STAFF REPORT

AGENDA ITEM TITLE: Sherman Hotel Major Certificate of Approval – 121 G Street

REQUEST: The request is to receive a Certificate of Approval on the following external work that is being proposed for the Sherman Hotel.

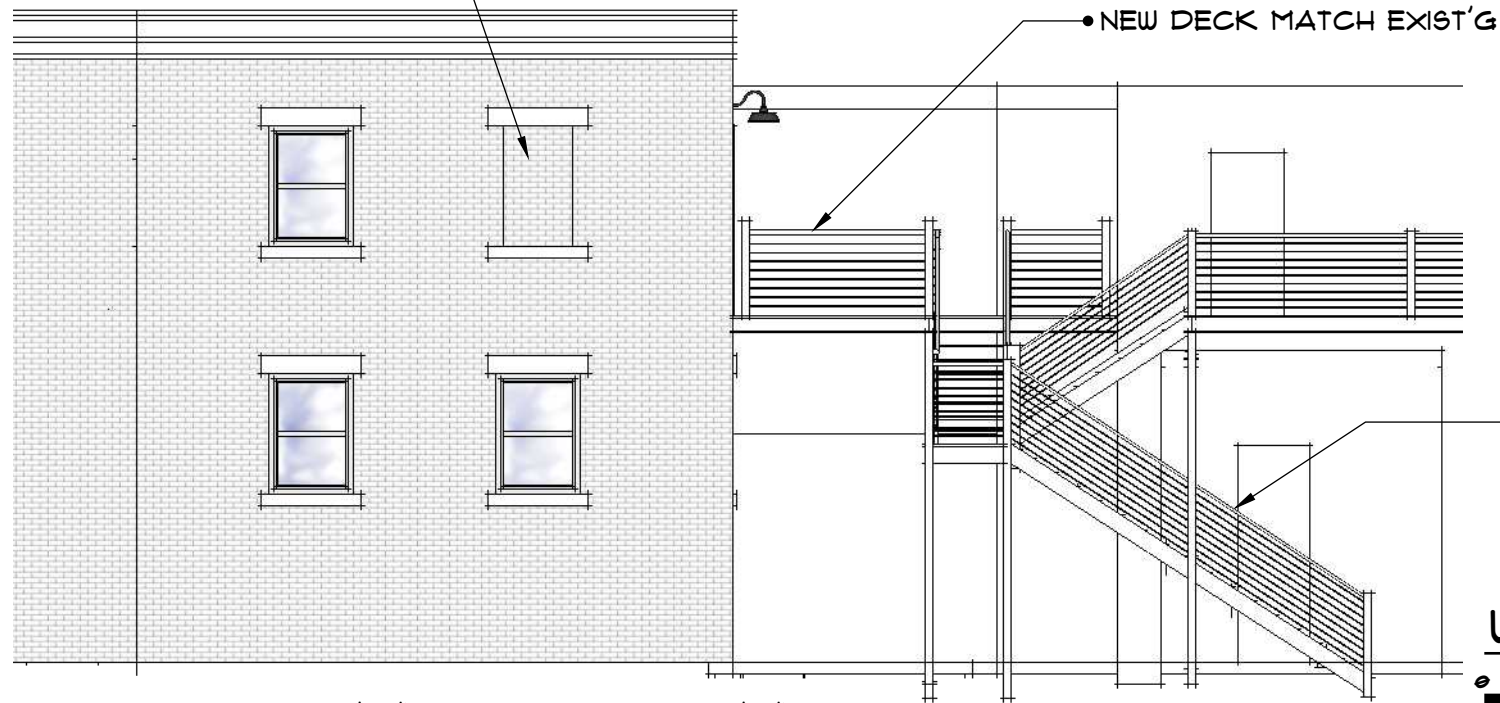
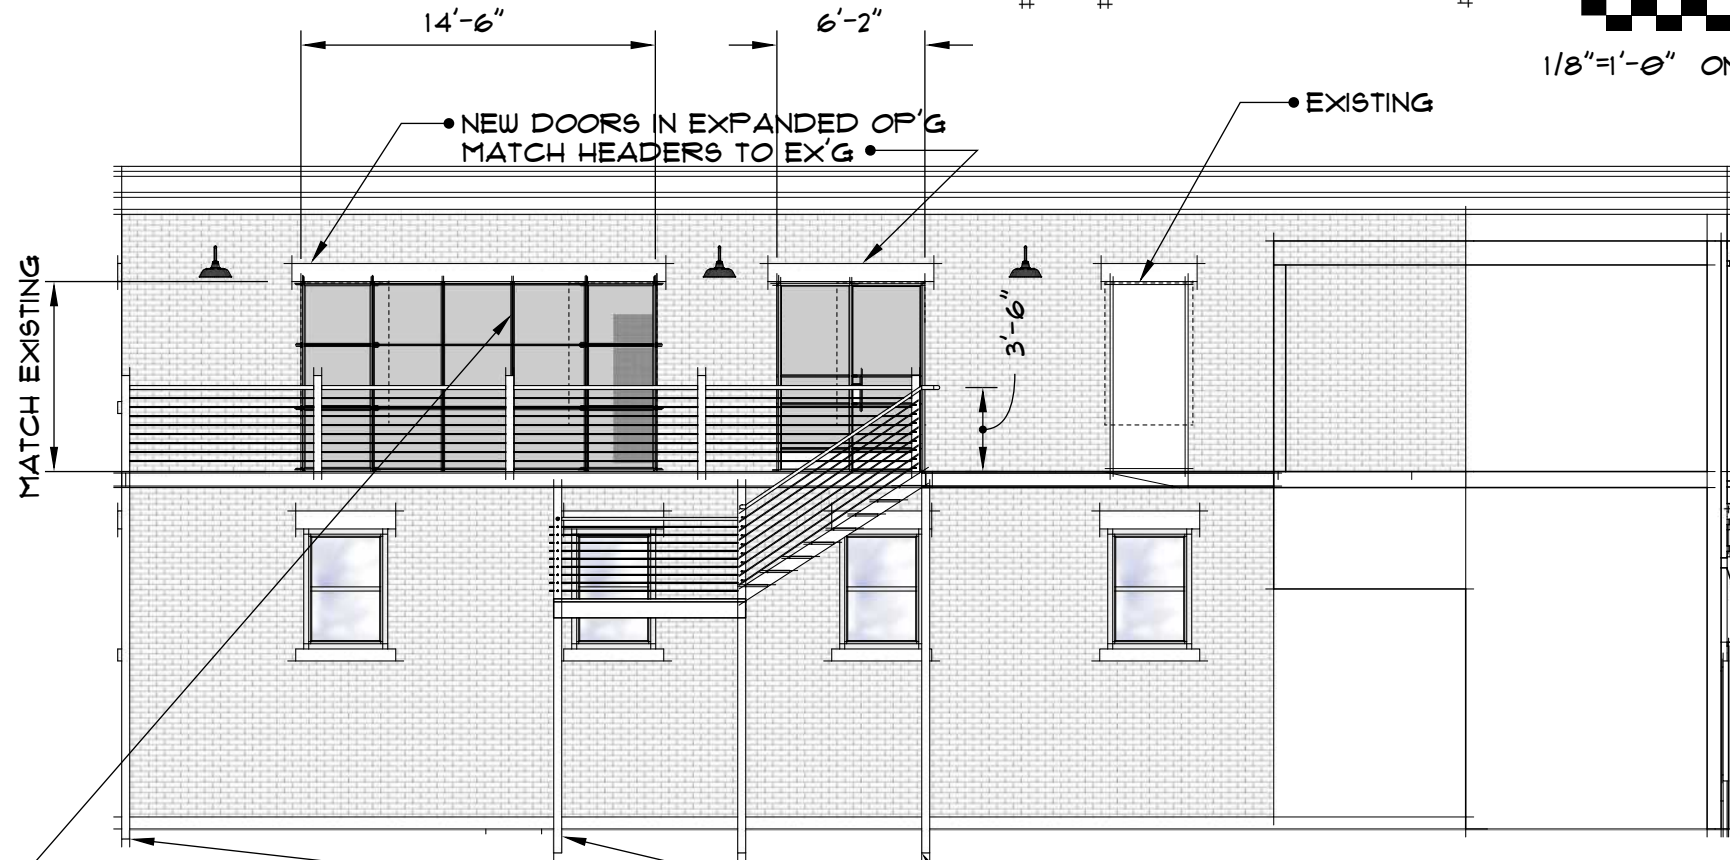
ITEM A: While enclosing a historic window opening is not generally considered appropriate, because this window is minimally visible the guidelines provide for greater flexibility. The window proposed for removal and brick fill is minimally visible from the street and therefore will only minimally impact the historic character. It will be filled with matching, historical brick, and the header and sill will be kept in place. This will preserve the option for re-installing a window in the future.

ITEM B: The removal of two windows and creation of a 14' 6" opening on a prominently visible façade – one that faces highly-trafficked First Street with a courtyard between the façade and First Street – will detract from the historic design. In the Salida Design Guidelines, Part 3. Rehabilitation Guidelines, Section C. Windows , Paragraph # 3 states: ***Preserve the position, number and arrangement of historic windows in a building wall.*** The removal of these two windows is in

conflict with that guideline. Part 4. States: ***Preserve the size and proportion of a historic window opening.*** The proposed expanded opening is significantly larger than the historic window opening, and the proportions of it change the opening from being two vertically oriented openings to one long horizontal opening.

ITEM C: The applicant is proposing to add a balcony the length of the north façade, tying into an existing balcony (not visible) and into the stairwell of the balcony approved in October 2014 for the adjacent 149-151 W. First Street building (visible). This proposal, because it matches an existing, recently approved balcony addition, will not detract from the appearance of historic features.

ITEM D: The applicant is proposing to remove a window and replace it with a taller and wider opening (6' 2" wide) to accommodate glass, double doors onto the proposed balcony. The existing window is not visible. The proposed expanded opening will be only slightly visible. It will be less visible than the previously approved single door openings in the adjacent 149-151 W. 1st Street Sherman Hotel building, and any portion that may be visible, will not exceed the width of a single-door opening.

ITEM A Original brick will be used to fill in the window on the east side.

ITEM B According to Part 3, Section C (6) of the Salida Design Guidelines "Replacement windows shall match to the fullest extent possible the appearance, function and materials of the original including glazing, including leaded and stained or painted glass". The windows are proposed to be replaced with doors. Material specification sheets have been provided. Replacing a brick wall with glass doors will not match the original materials.

ITEM C: The balcony materials will match the existing balcony. The existing balcony is not original, however it received a Certificate of Approval in October 2014.

ITEM D: The window is proposed to be replaced with a door, and the brick wall opening expanded. Material specification sheets have been provided. Replacing a brick wall with

glass doors will not match the original materials, however, this is in a minimally visible area and only a portion of the opening could potentially be visible from the street.

ITEM B: The proposed expanded glass accordion doors will require more than a minimal change to the historic appearance, materials or integrity of the structure. It is a significant change that is visible from First Street right-of-way.

Item B would detract from the existing historic structure by changing out two historic windows for a much larger opening with glass doors on a prominently visible facade. Items A & D are minimally visible and would not detract from the historic structure, and Item C is a continuation of a previously approved deck using the same materials.

1. That the Commission **APPROVE** the filling in of one window on the east side of the building with original brick (Item A), the addition of the proposed balcony (Item C), and the removal of a window and expanded opening to 6' 2" to accommodate double patio doors at the west end of the north façade (Item D).
2. That the Commission **DENY** the 14' 6" opening on the east end of the north façade proposed to replace two existing windows and the brick façade between them with a glass façade of accordion patio doors (Item B).

I move to **APPROVE** the major certificate of approval for Items A, C, and D identified herein, and **DENY** the major certificate of approval for Item B.
